**WISDOM
INDUSTRIES, Ltd.**

SERVICE BULLETIN

DATE: FEBRUARY 4, 2000
RIDE: ALL SMALL COASTERS
SUBJECT: COASTER WHEEL BRACKETS
COMPLIANCE DATE: IMMEDIATE

WISDOM INDUSTRIES Merino, CO 80741		APPROVED BY:	
SLOT REINFORCEMENT		SCALE:	NTS
		DATE:	02/04/00
IPMENT: COASTERS		DRAWN BY:	SMY
		DRAWING NUMBER:	SBSLOT2

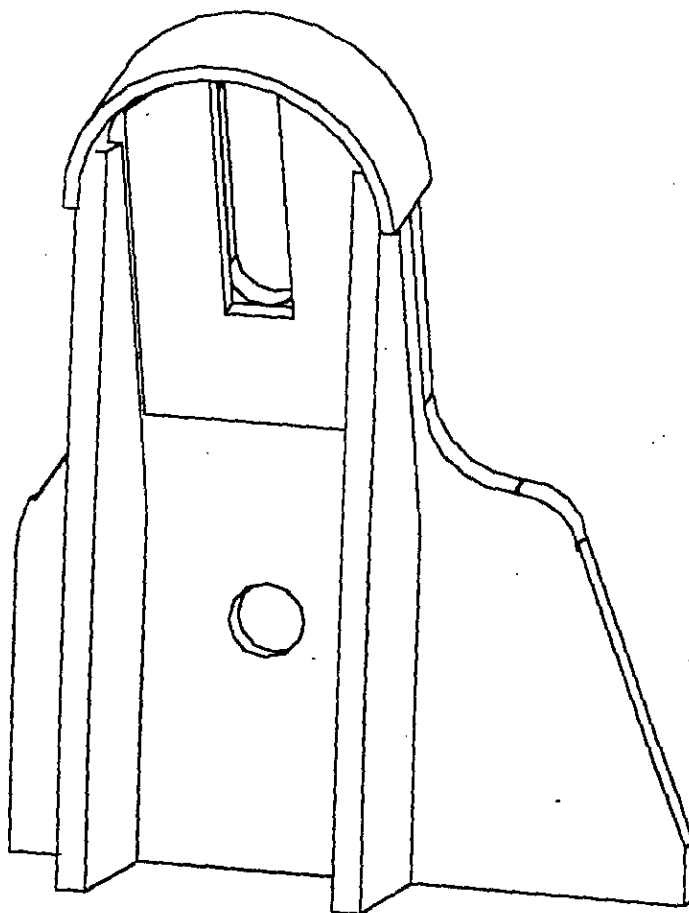
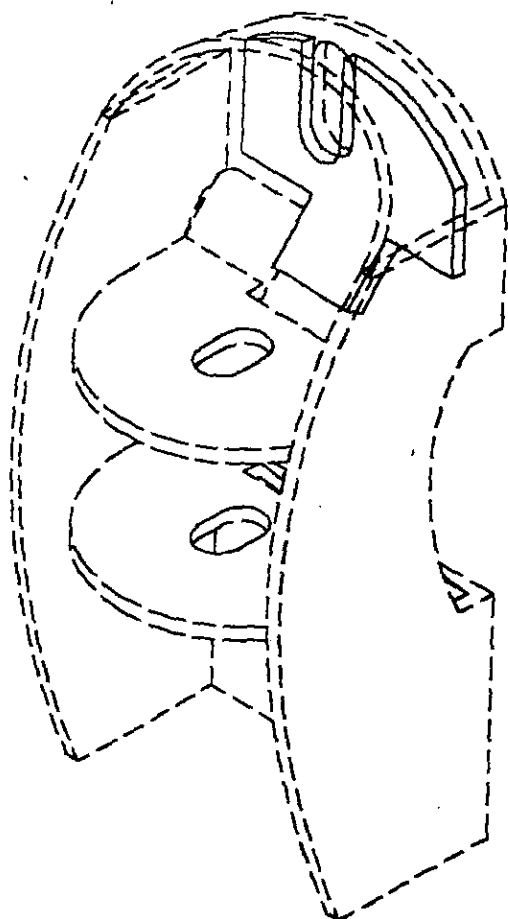
There have been a few instances of cracks in or around the slotted hole in the fixed type wheel brackets used on the smaller coasters, such as the Dragon Wagon, Go Gator, Clatterpillar and Miner Mike.

It is important to use only flange type nuts in this slotted area and check nut on a regular basis to ensure it is tight

Cracks can be field repaired. Grind a groove into the crack at least $\frac{3}{4}$ of the thickness of the base metal and slightly beyond the crack in both directions. Make sure area is clean and free of any grease. Weld with E7018 electrode and grind flush where weld or nut comes in contact with plate.

If cracks are found a doubler plate can be added to the wheel slot area. Contact Wisdom Industries for doubler plates. See the enclosed drawing for location of doubler plate.

REPAIR CRACKS AROUND SLOT BEFORE INSTALLING PLATE. PLACE REINFORCEMENT
 PLATE INTO WHEEL BRACKET ALIGNING SLOT AND TAB. WELD AROUND PERIMETER OF
 REINFORCEMENT PLATE. FLANGE NUT MUST BE USED ON WHEEL BOLT.
